Proposed Burlington Quarry Expansion **JART COMMENT SUMMARY TABLE – Visual Impact Assessment**

VISUAL IMPACT ASSESSMENT

PROPOSED EXTENSION OF THE BURLINGTON QUARRY

Part Lot 1 & 2, Conc. 2 and Part Lot 17 & 18, Conc. 2
City of Burlington, Ontario

Figure 4
Assessed Views Photo Location Map

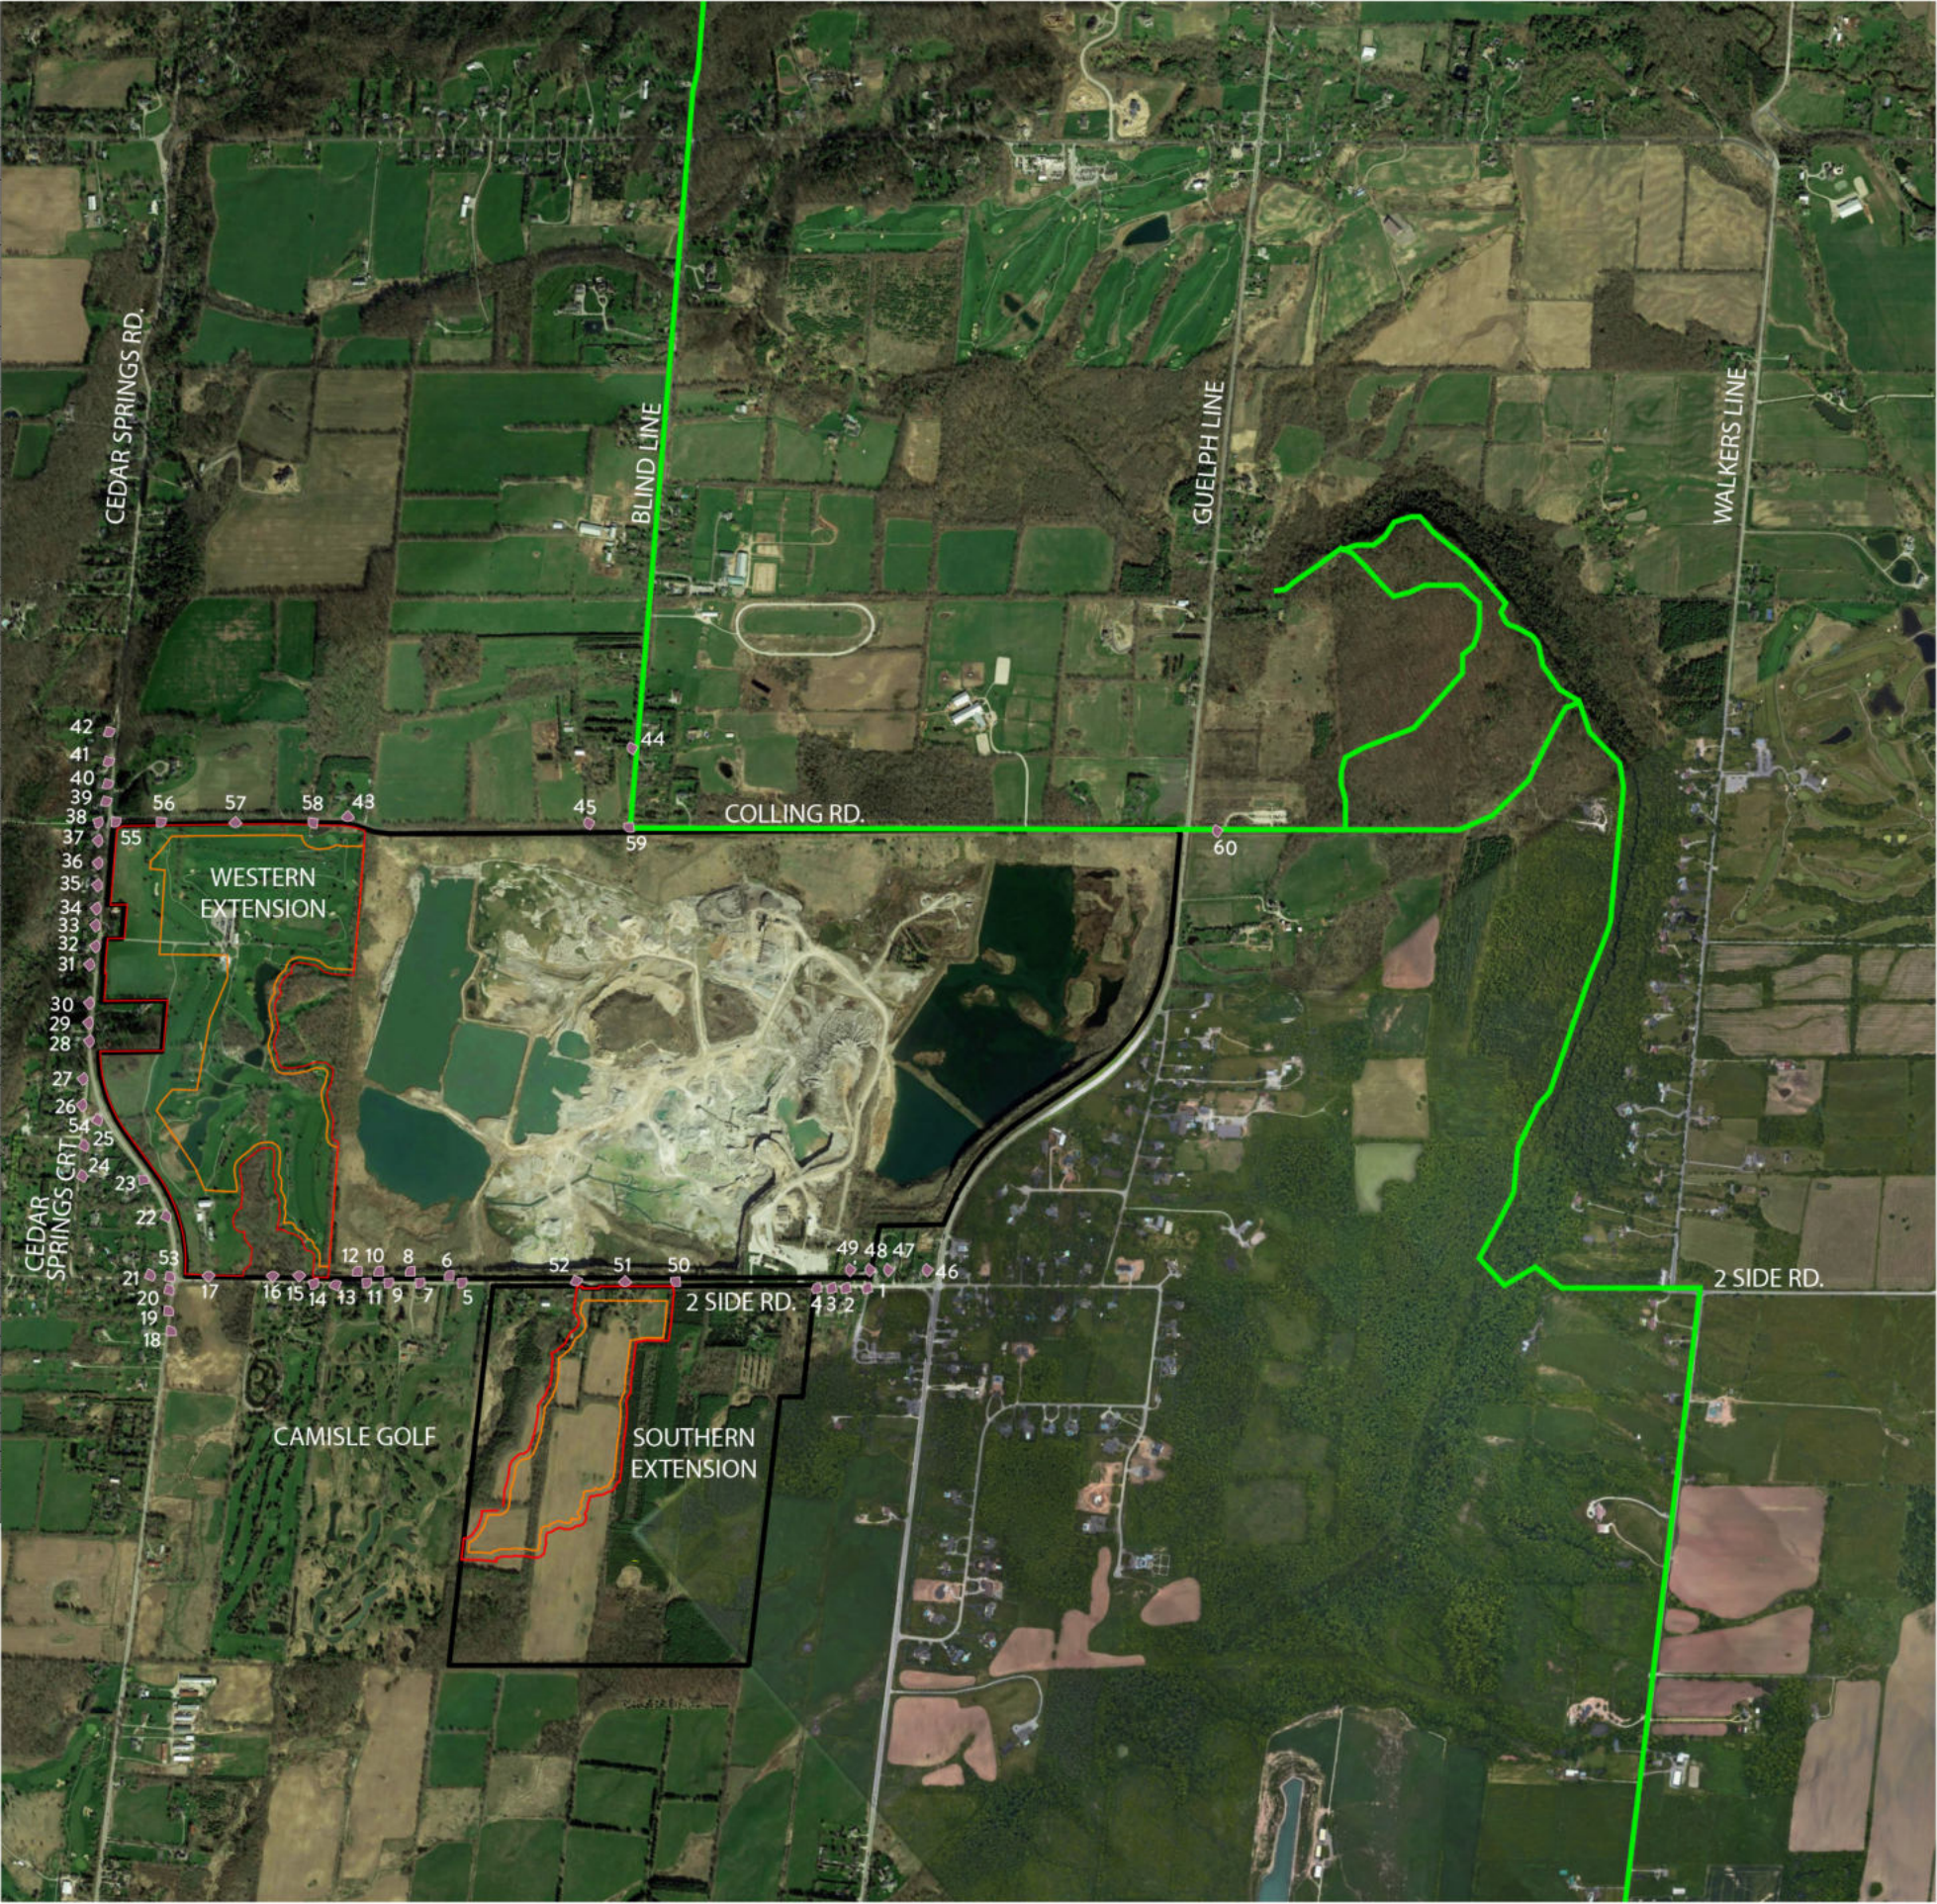
<ul style="list-style-type: none"> Figure 4 Photo Location Map: VIAs must be accurate and replicable. This map is unreliable for determining the exact photo locations as there are a few errors in symbol placement and direction. This can be addressed with minor corrections (i.e. #21, 24, 25, 32) and by adding GPS and other details to the Photo Record. Label quarry extension names, road names, Bruce Trail route, and golf courses for reference on this map. 	<p>Receptors have been adjusted. Labels have been added.</p> <p>See updated report dated June 2021.</p>	
<ul style="list-style-type: none"> Viewpoints: The following additional viewpoints are required to fully assess views from public roads, public lands, and the Bruce Trail. Visibility or lack of visibility must be documented in the Photo Record. <ul style="list-style-type: none"> o View from No. 2 Sideroad looking SW into South Quarry Extension o View from No. 2 Sideroad looking S into South Quarry Extension o View from No. 2 Sideroad looking SE into South Quarry Extension o View from the intersection of Cedar Springs Road/No. 2 Sideroad looking N into West Quarry Extension o View along Cedar Springs Court access road looking NE into West Quarry Extension o View from intersection of Cedar Springs Road/Colling Road looking SE into West Quarry Extension o View from Colling Road looking SE into West Quarry Extension o View from Colling Road looking S into West Quarry Extension o View from Colling Road looking SW into West Quarry Extension o View from Bruce Trail/intersection of Colling Road/Blind Line looking W into West Quarry Extension o Photo 13 - shift orientation to the north to document more of the existing roadside vegetation at the eastern limit of the West Quarry Extension 	<p>Photo receptors have been added and shifted as suggested.</p> <p>See updated report dated June 2021.</p>
